# ADDENDUM 1 CSP 23-24 GYMNASIUM ADDITIONS/IMPROVEMENTS FOR GUERRA & VILLARREAL ELEMENTARY SCHOOLS November 8, 2022

# ADDENDUM NUMBER [\_\_\_1\_\_]

DATE: [	<u>[22]</u>	
PROJECT: E.C.I.S	S.D. Villarreal Elementary School – Gym	
PROJECT NUMBE	ER: 23-24	
OWNER: Edinbu	rg CISD	
ARCHITECT: Ne	grete & Kolar Architects, LLP	
TO: Prospective	Bidders	
	forms a part of the Contract Documents and modifies the Bidding D ,, with amendments and additions noted below.	ocuments dated
Acknowledge re	eceipt of this Addendum in the space provided in the Bid Form. Failu	re to do so may disqualify t
This Addendum	consists of <u>17</u> pages and the following Drawings:	
No.	Drawing Title	Issue Date
1	G.001 - Drawing Index	11/7/2022
2	EX.01 – Interior Elevations	11/7/2022

1 DEDICATORY PLAQUE LOCATION

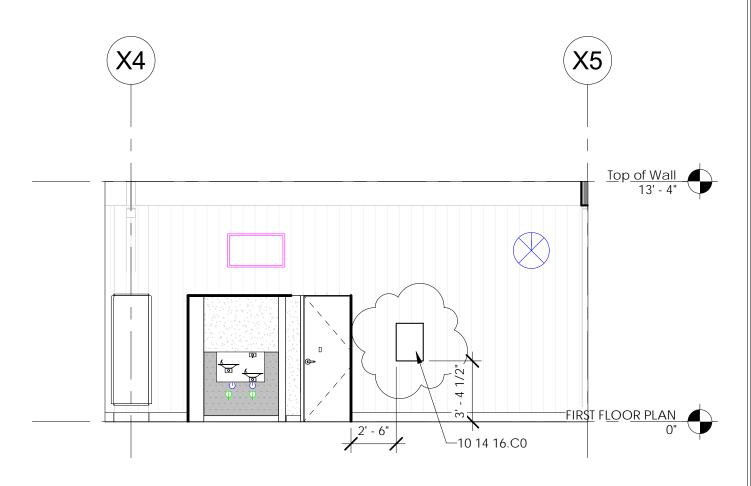
EX.01 - Interior Elevations; Indicate location for Dedicatory Plaque

10 14 16.C0 Cast Dedicatory Plaque

WALL LAYOUT PLAN

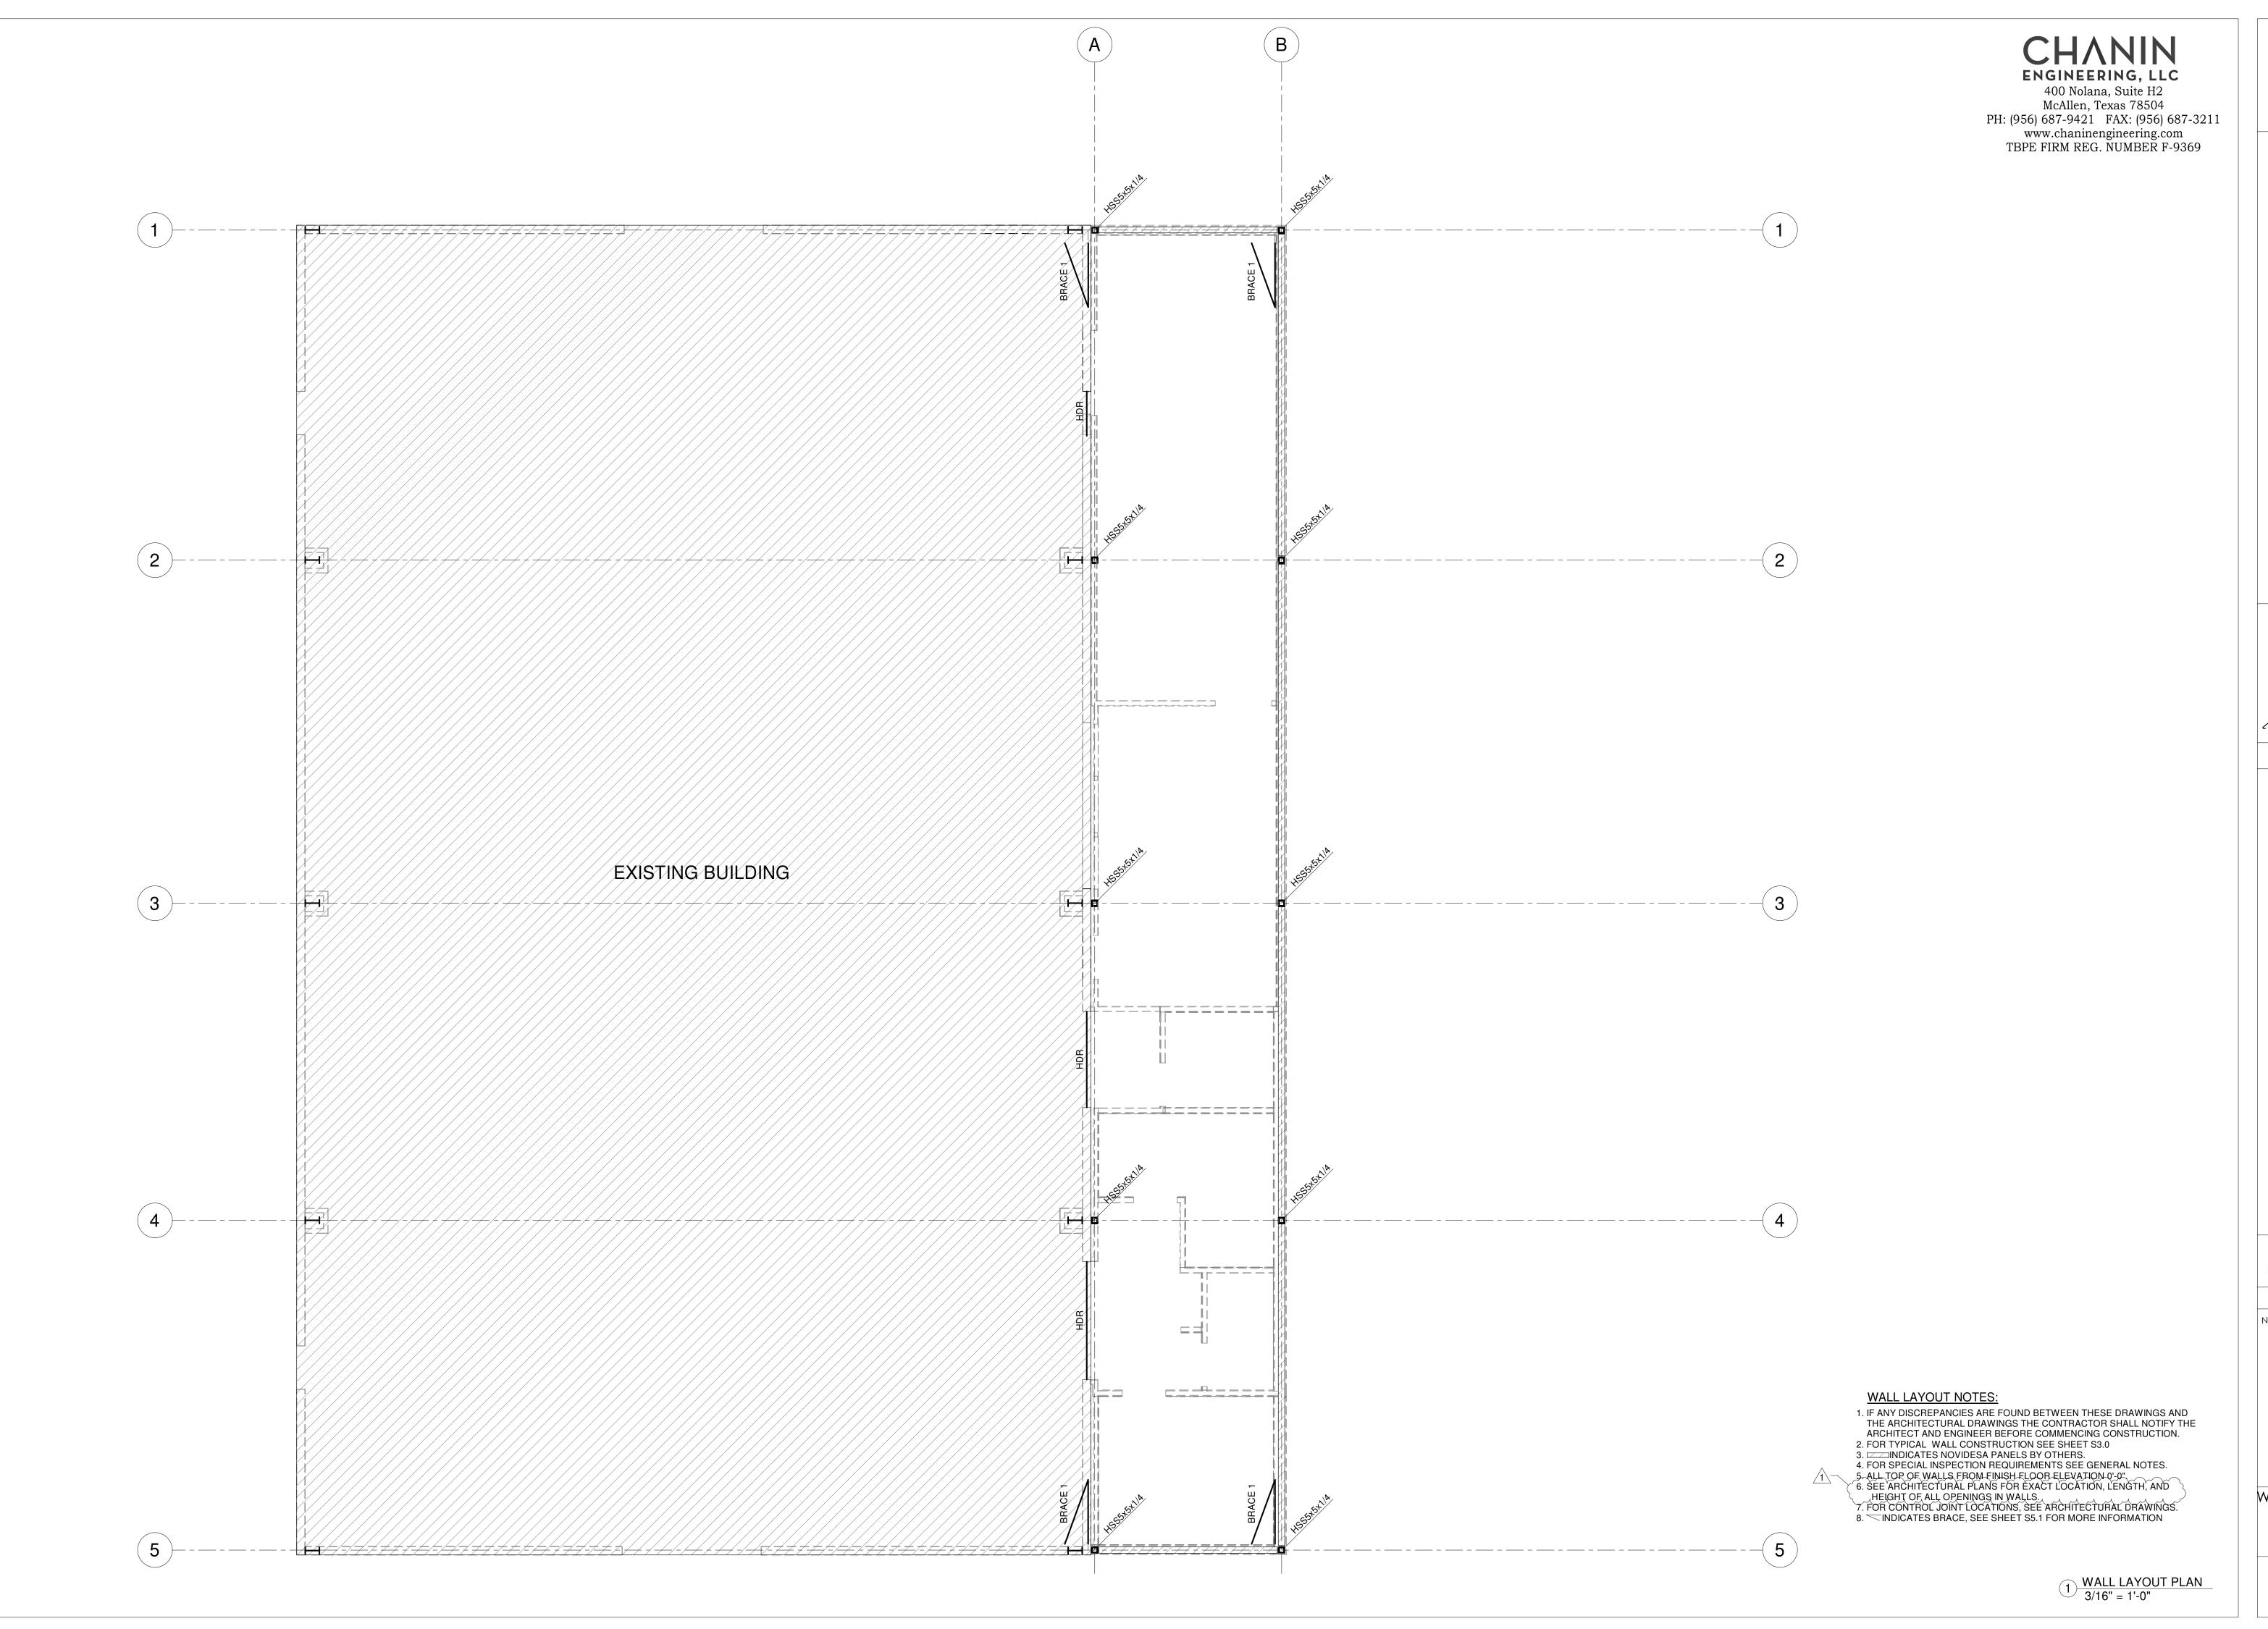
S3.0 - Wall Layout Plan; Revise CMU Wall Layout Notes to Structural Insulated Panel Wall Notes:
